**Broyles and Associates**  
structural engineers

Re.: Dollar Tree – Western Plaza, 2085 N. Marine Blvd., Jacksonville, NC 28546  
Structural Report on Findings, Site Visit (April 14, 2015)

Photo #7 – Crack at rear corner of building extends for full height of wall. We recommend replacement of cracked CMU and repointing. This is typical of several areas on the rear and side walls.

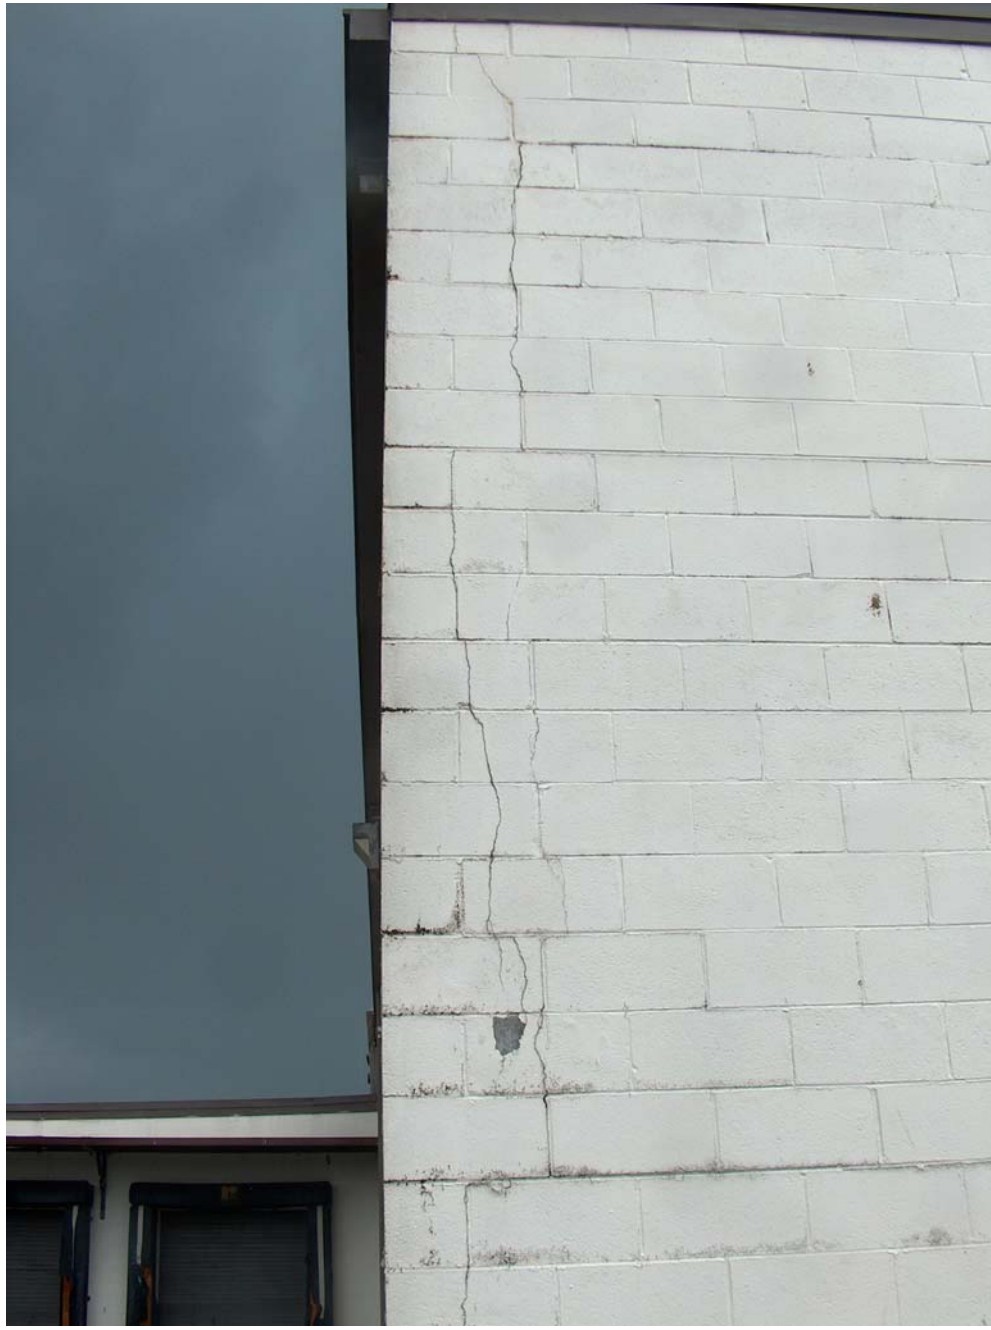
We did not quite a bit of cracking of the exterior CMU walls on the rear and left side walls. The crack at the corner of the wall (adjacent to the loading dock) is cracked for the entire height of the wall (See Photo #7). According to the current tenant, there is moss growing on the inside of the wall (a bit of an exaggeration, however, there is quite a bit of cracking). There is also cracking above both egress exterior door openings (See Photo #8). It appears that the cracks are relatively small but are open to the elements and allow water to enter the building. It appears that the cracks are from settlement and that the rear of building footprint was built up. We recommend that the landlord address the cracks and report as required. In the case where the CMU units are cracked, we recommend replacement and tooling back into the wall. Please note that the wall thickness on the rear and side walls is 12" and both walls are essentially bearing.

As noted above, the major structural issue with existing building (Dollar Tree portion) involves the exterior masonry cracking – particular around the rear corner of the building. We recommend that cracked CMU be removed and repointed back into place. There are other cracks too that need to be repointed along the rear and side walls. This is needed to prevent water infiltration into the stockroom and sales areas. If new mechanical units are replaced, we recommend that they be located at the existing locations – if possible. Some steel support may still be needed depending upon the size and location of units. There will need to be some remedial work done at the egress doors. A new concrete ramp and landing is anticipated. The recessed truck well and loading dock can be used for Dollar Tree without any modification. We recommend some remedial work be done over the lintel beam heading into the loading dock area.
